DEPARTMENT OF PERMITTING SERVICES

Re: **COMBINED STORMWATER MANAGEMENT
CONCEPT/SITE DEVELOPMENT
STORMWATER MANAGEMENT PLAN (Phase
1) and a CONCEPT PLAN (Phase 2)** for
Westwood Shopping Center
Preliminary Plan #: 120170170
Site Plan #: 820180190
SM File #: 282495
Tract Size/Zone: 16.55Ac./CRT-2,5,2.0,1.5,&1.0
Total Concept Area: 16.34 Ac.
Lots: A-4
Parcel(s): 360
Watershed: Little Falls Branch

RE: Preliminary Plan No. 120170170
Westwood Shopping Center
Traffic Impact Study
Traffic Signal Warrant Study

RE: Preliminary Plan No. 120170170
Westwood Shopping Center
Revised

SECTION A-A
 PROPOSED
 WESTBARD AVENUE
 PUBLIC ROADWAY
 FACING RIVER ROAD
 SCALE: 1"=10'

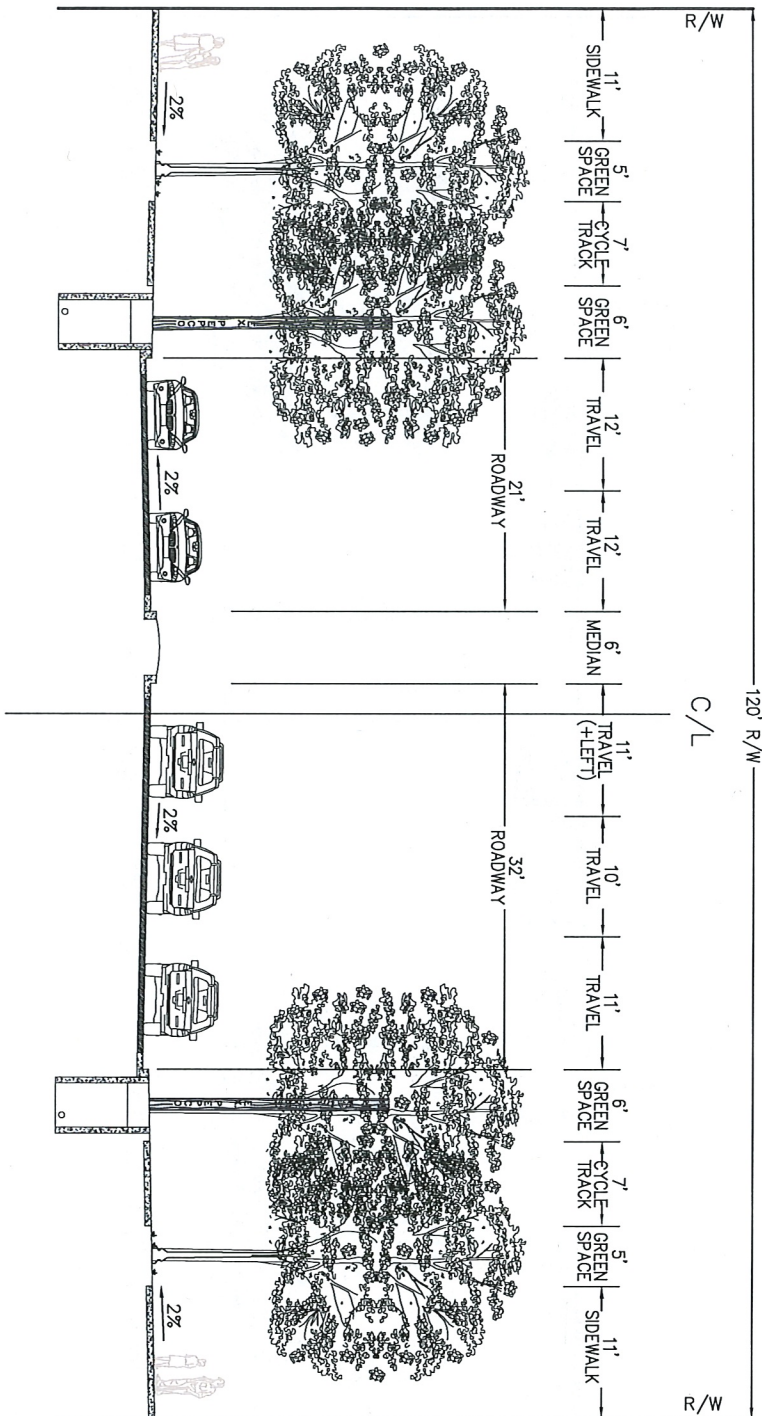
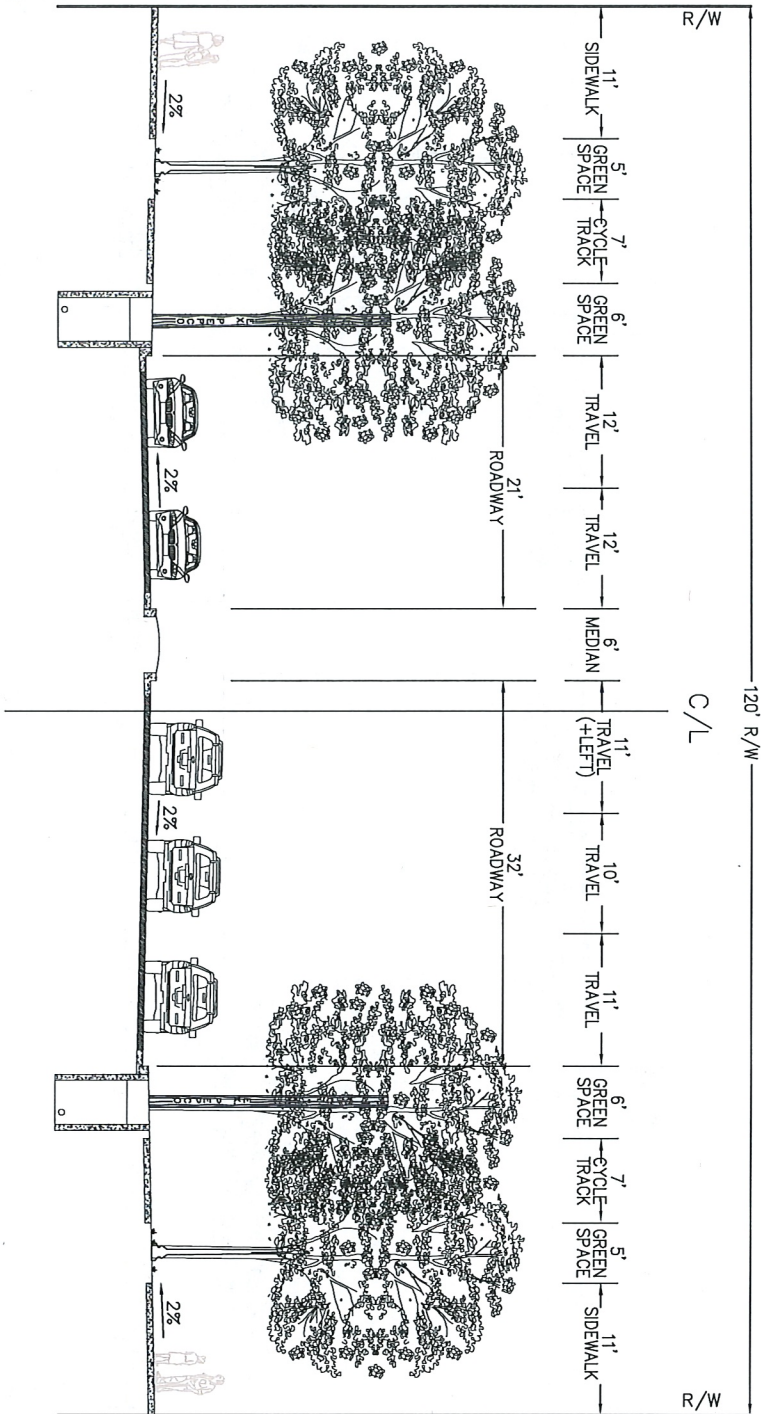
- a. Cross-Section X-X ("A-A" and "B-B" in plans dated October 19, 2018) included as "Exhibit A": Right-of-way widening from 70 feet to 117 feet, a new eastbound lane added. The revised road section would also include a new seven-foot-wide separated bike path along the west side of Westbard Avenue, to the south of proposed realignment.

MCDOT Response: The entire cross section from River Road to where the third travel lane is dropped is eligible for credit. The right-of-way is **not eligible** for credit per County Code 52-47(b)(5).

SECTION C-C
 PROPOSED
 WESTBARD AVENUE
 1"=10'

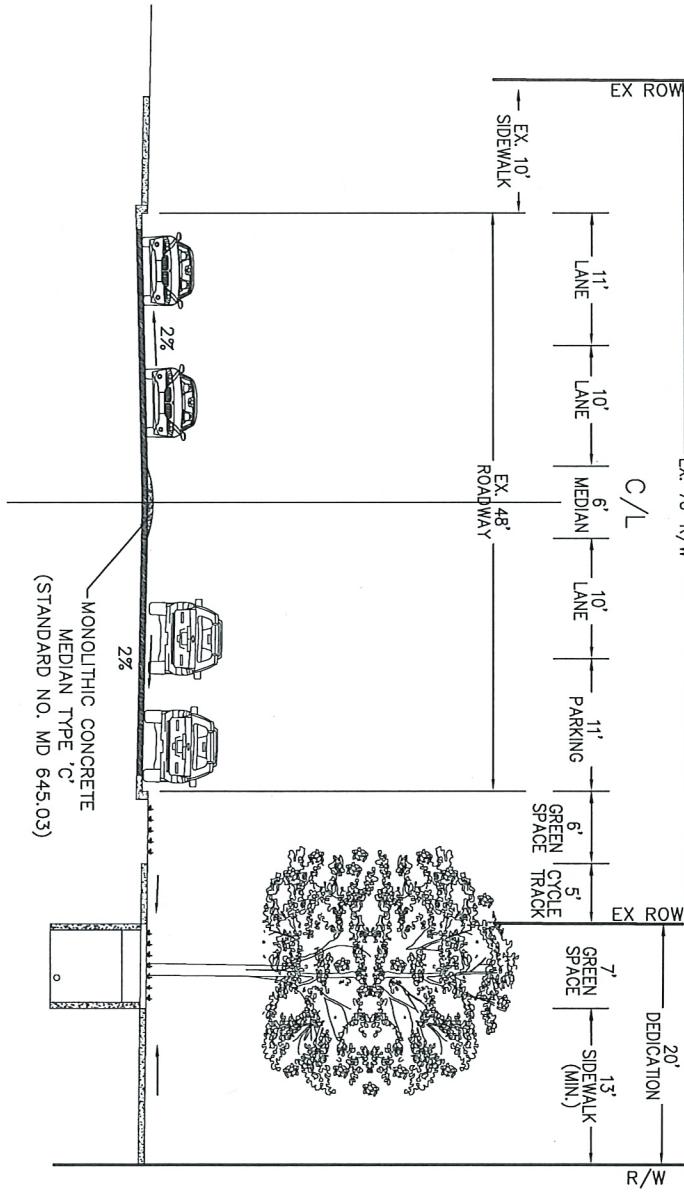
- b. Cross-Section "Y-Y" ("C-C" on plans dated October 19, 2018) included as "Exhibit A":
Introducing a new seven-foot separated bike path along the west side of Westbard Avenue, to the south of the proposed realignment.

MCDOT Response: The separated bike path is **not eligible** for credit per County Code 52-39. There is an existing sidewalk and green panel in the current location. The 13-foot wide sidewalk and the 7-foot wide green space **is eligible** for credit. The right-of-way is **not eligible** for credit per County Code 52-47(b)(5).

FIRE DEPARTMENT ACCESS PLAN

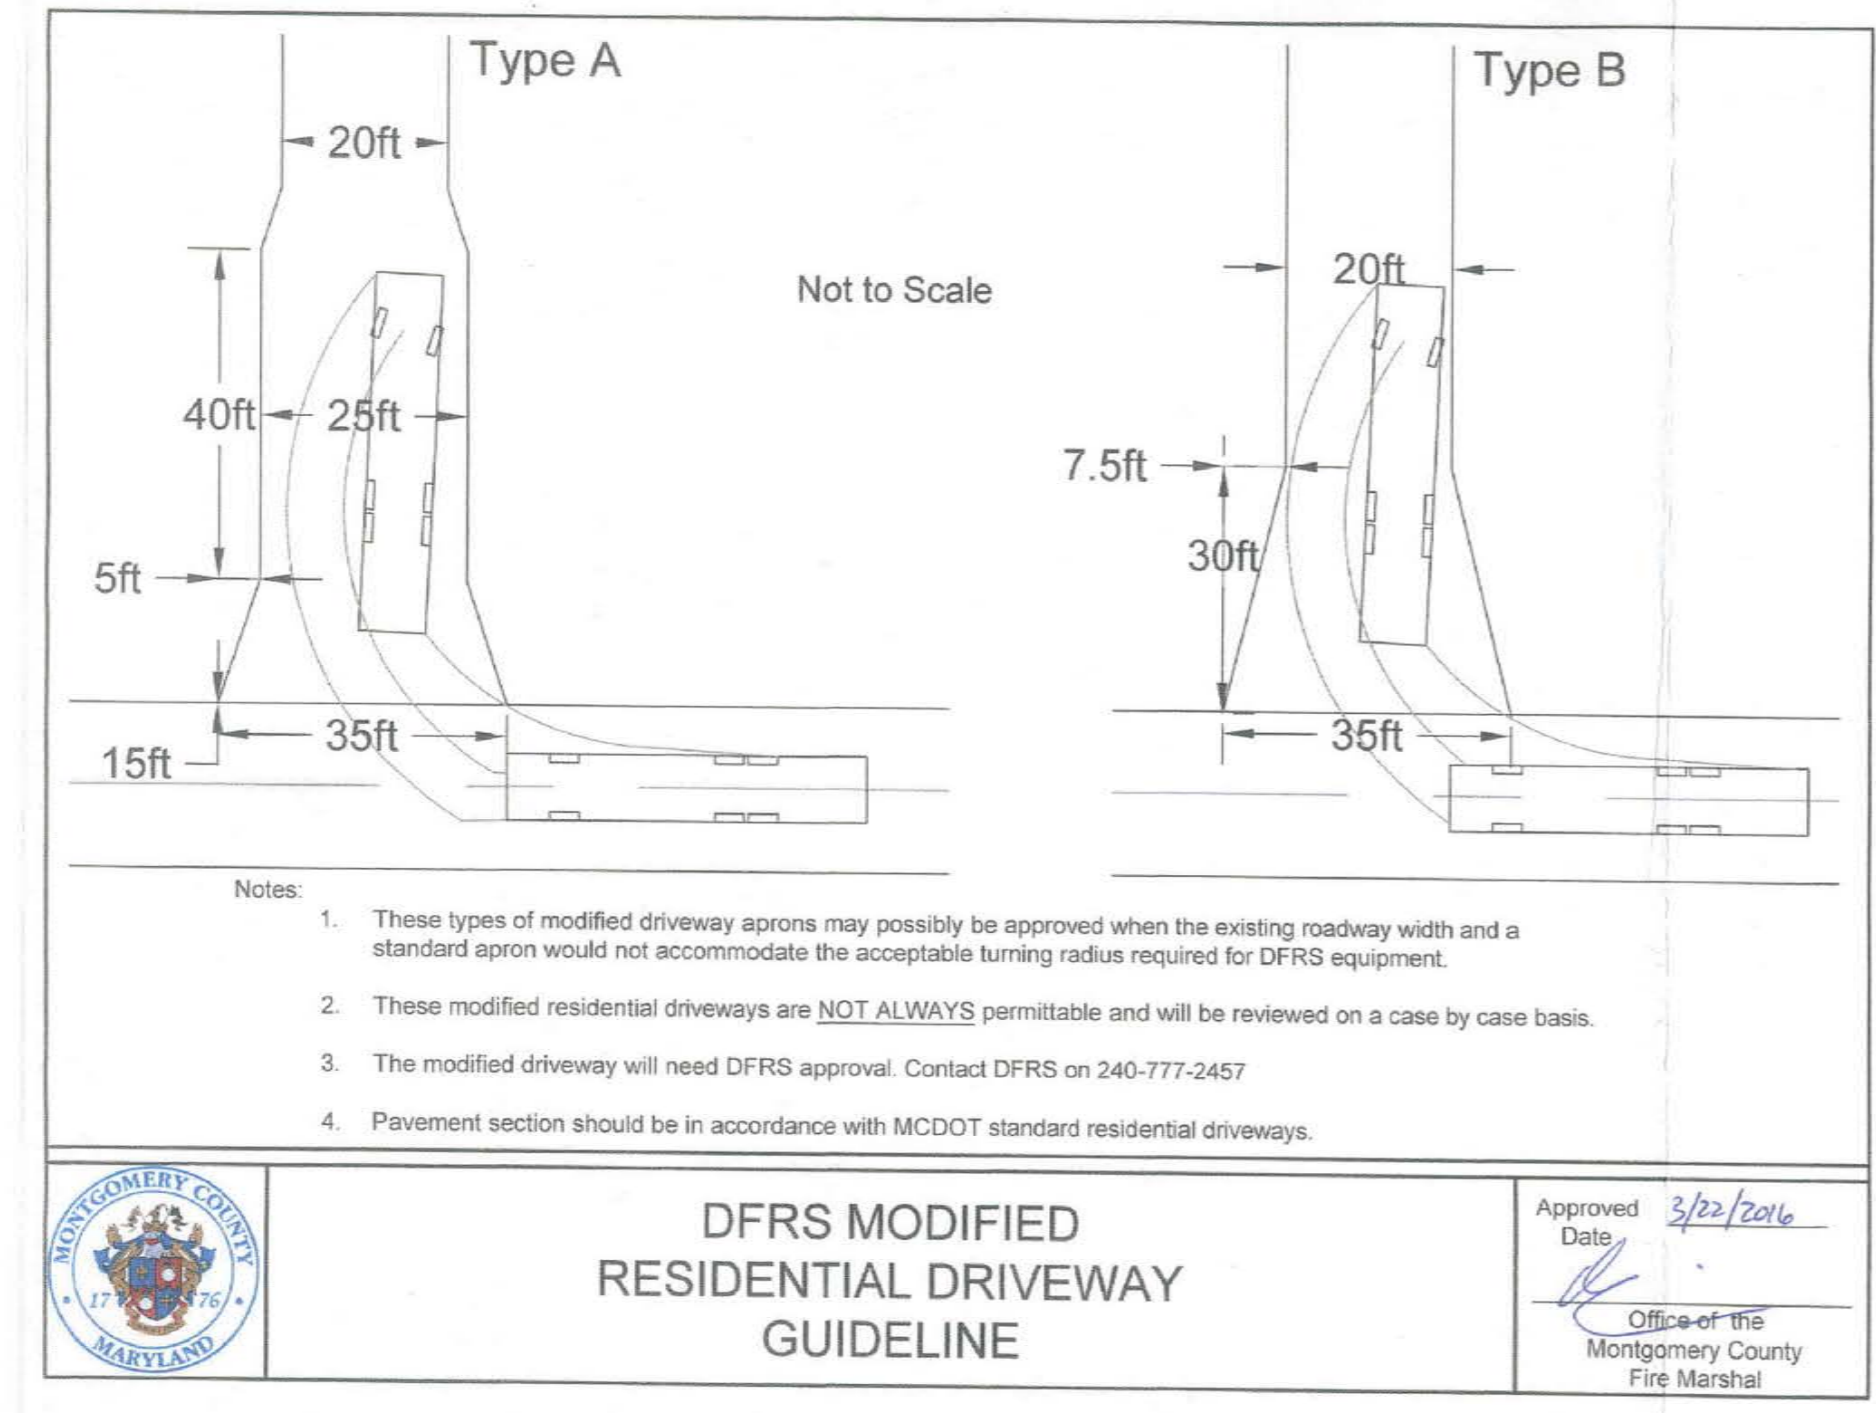
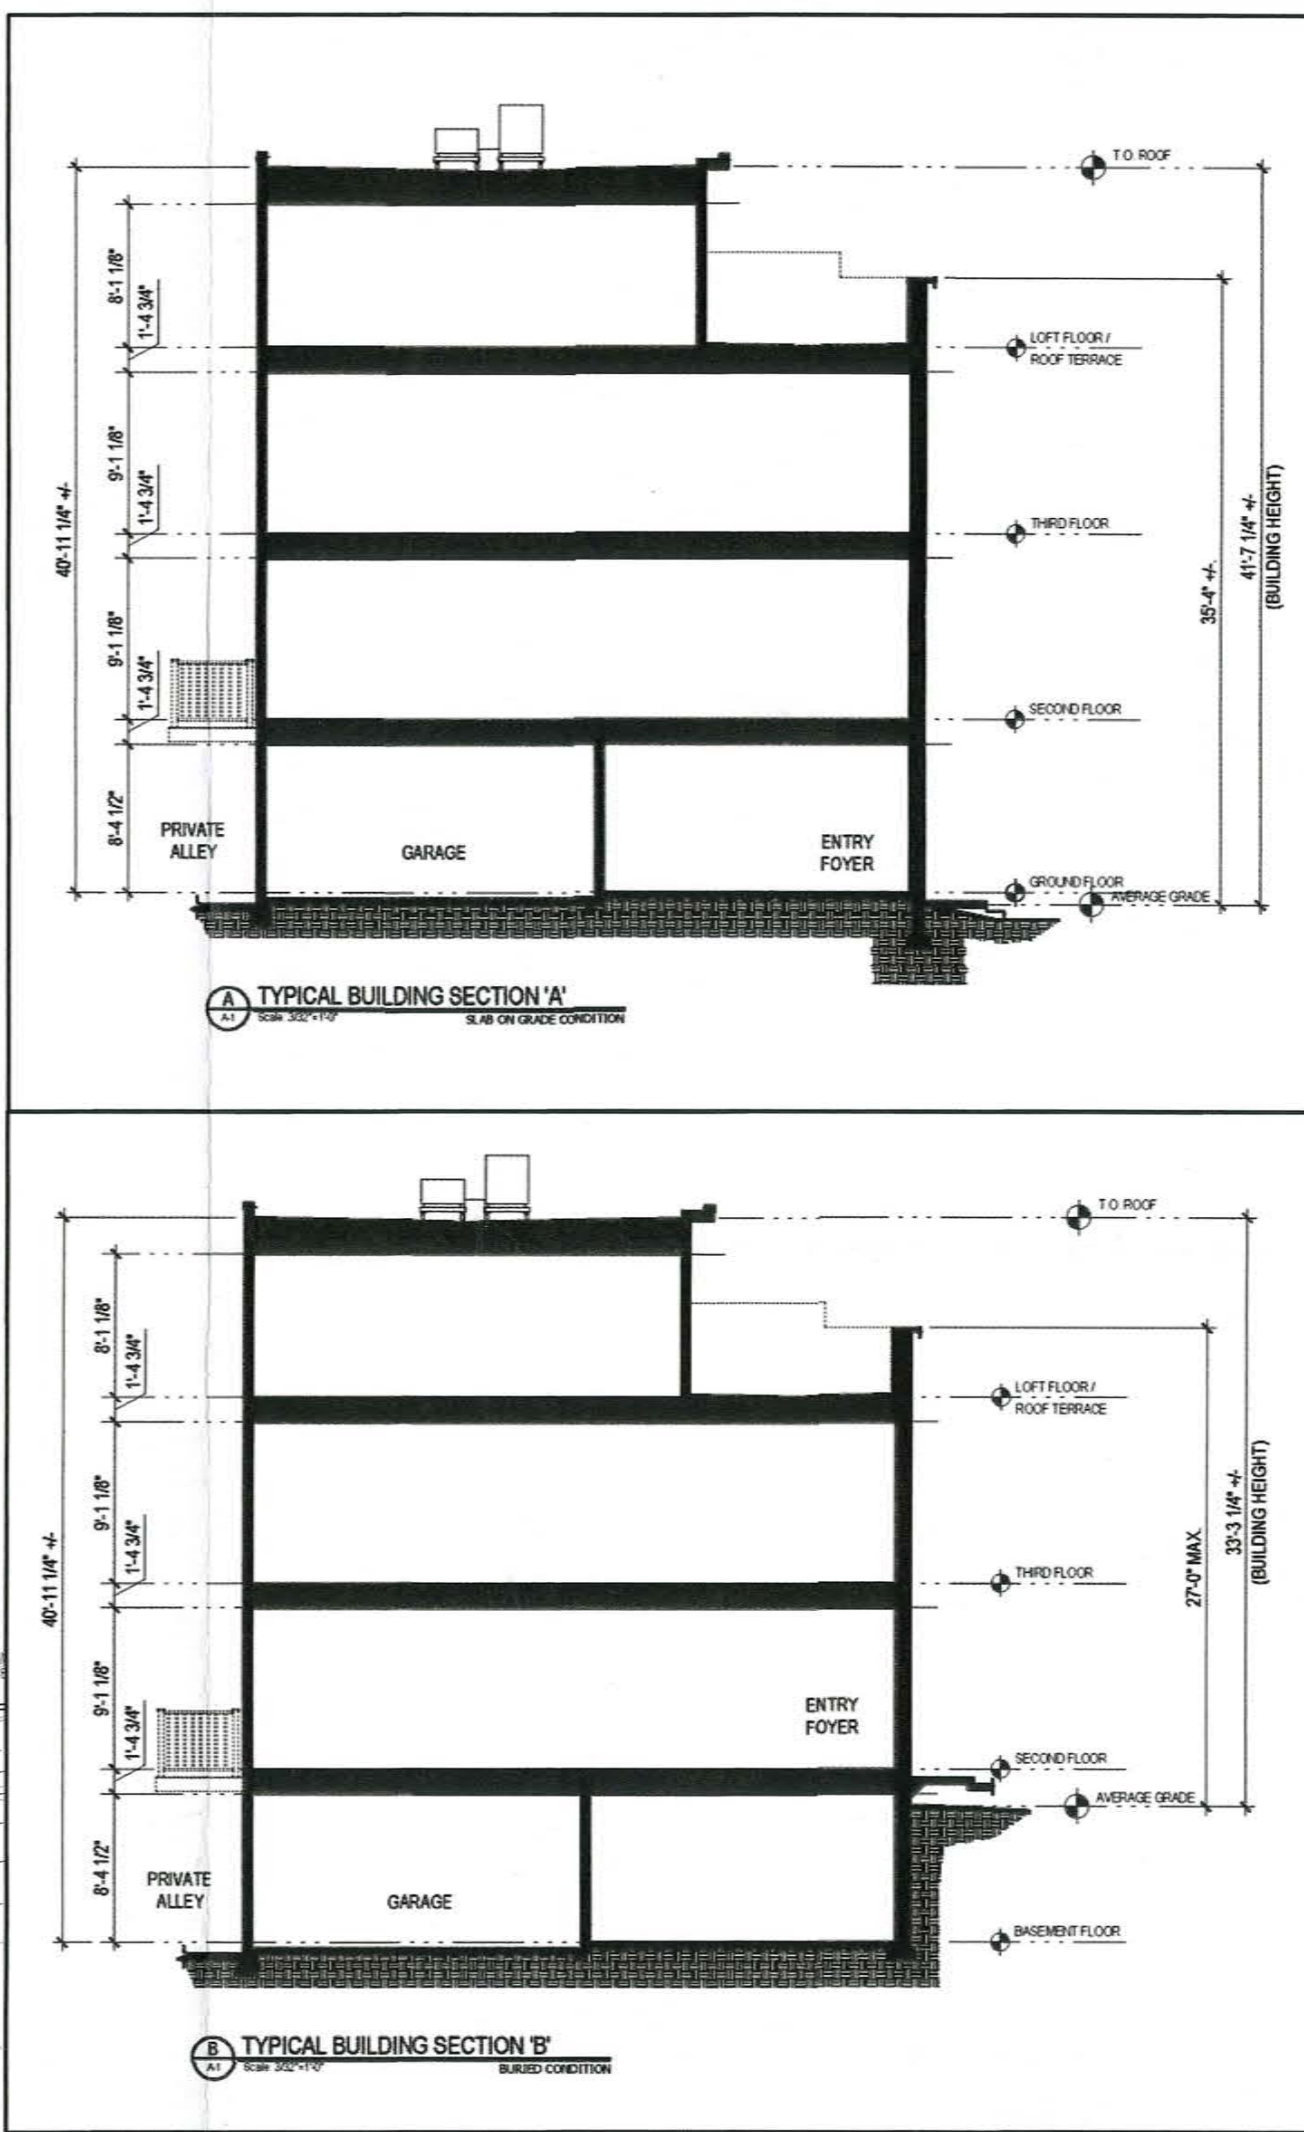
***** Parking restrictions required at site plan *****
